VIRGINIA ELECTRIC AND POWER COMPANY
RICHMOND, VIRGINIA 23261

VIRGINIA ELECTRIC AND POWER COMPANY
NORTH ANNA POWER STATION UNITS 1 AND 2
PROPOSED IMPROVED TECHNICAL SPECIFICATIONS
REQUEST FOR ADDITIONAL INFORMATION – ITS 3.0, 3.5 & 4.0

**North Anna Improved Technical Specifications (ITS) Review Comments
ITS Section 3.0, LCO and SR Applicability**

Figure 9.1-3
FUEL PIT AREA; PLAN AND ELEVATION

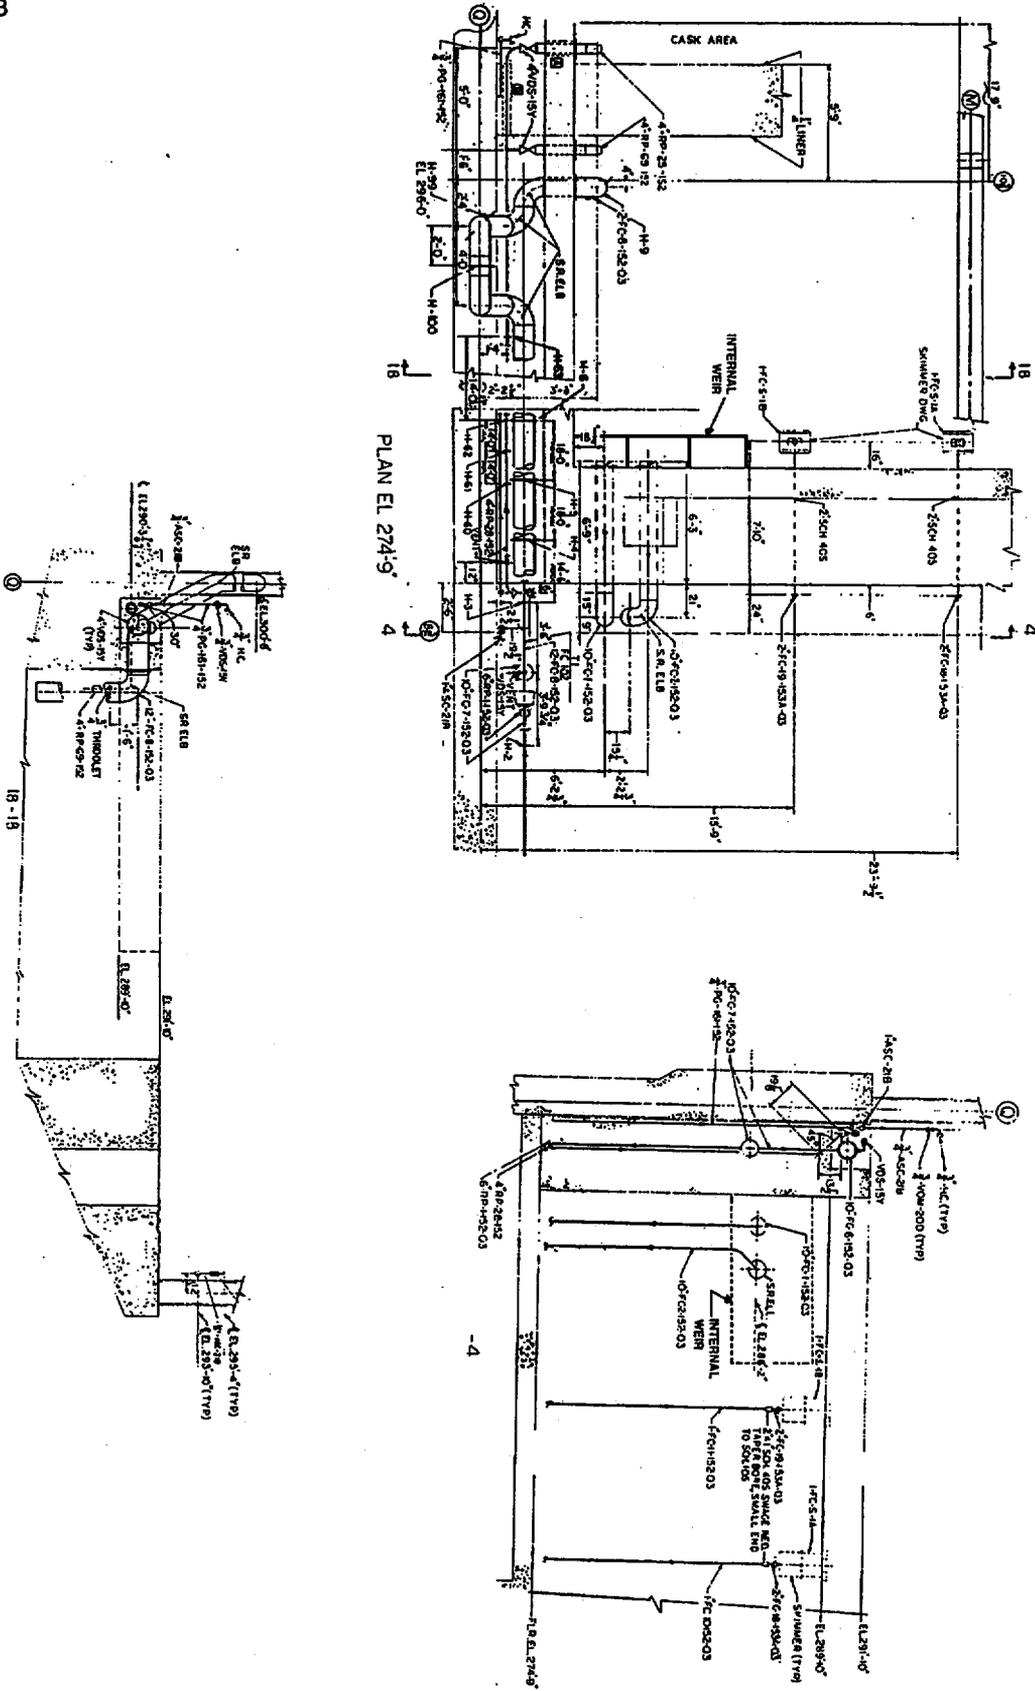
NRC RAI: ITS 4.3.2 Drainage states that to prevent inadvertent draining of the pool below elevation 288.83 Mean Sea Level, USGS datum which is North Anna plant specific value.

Comment: Explain with figure of fuel storage pool why this value is equal to 23 ft elevation.

Response: The Company will take the action proposed in the Comment, with certain modifications. UFSAR figure 9.1-3 and the relevant portion of UFSAR 9.1.3.3.3 (Revision 36) are attached.

No means exist for completely draining the spent-fuel pit using installed systems and equipment. Figure 9.1-3 shows all piping connections to the spent-fuel pit, including any pipes that dip into the pool that can act as siphons, and the internal weir. The water level could be lowered to Elevation 285 ft. 9 in., which is 4 ft. 1 in. below the normal water level and 23 ft. 1 in. above the fuel, by incorrect operation of, or a failure in, the fuel pit cooling and refueling purification system. In these instances, detailed below, an adequate water level would exist over the fuel to provide for cooling and radiation protection.
